Product Change Notification

Product	Model Name	Device ID
ARTIK305s	SIP005AFS30	SIP-003AYS052
ARTIK530s	SIP005AFS30	SIP-005AFS302
ARTIK530s 1G	SIP005AFS30	SIP-005AUS332
ARTIK710s	SIP007AFS00	SIP-007AFS002
ARTIK711s	SIP007AUS11	SIP-007AUS112

Change the phrase on the Aluminum Bag

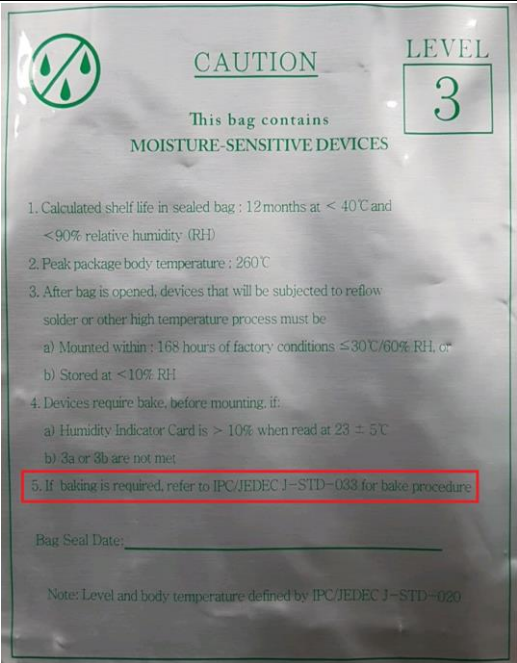
In order to provide more specific information to the customer, SAMSUNG decided to change the phrase on the aluminum bag as shown in the table below. This phrase is for baking condition, and has been changed from a standard document number to a specific condition.

As-is		
To-be	5. If baking is required, devices may be baked for 24 hours at 125 +5/-0°C
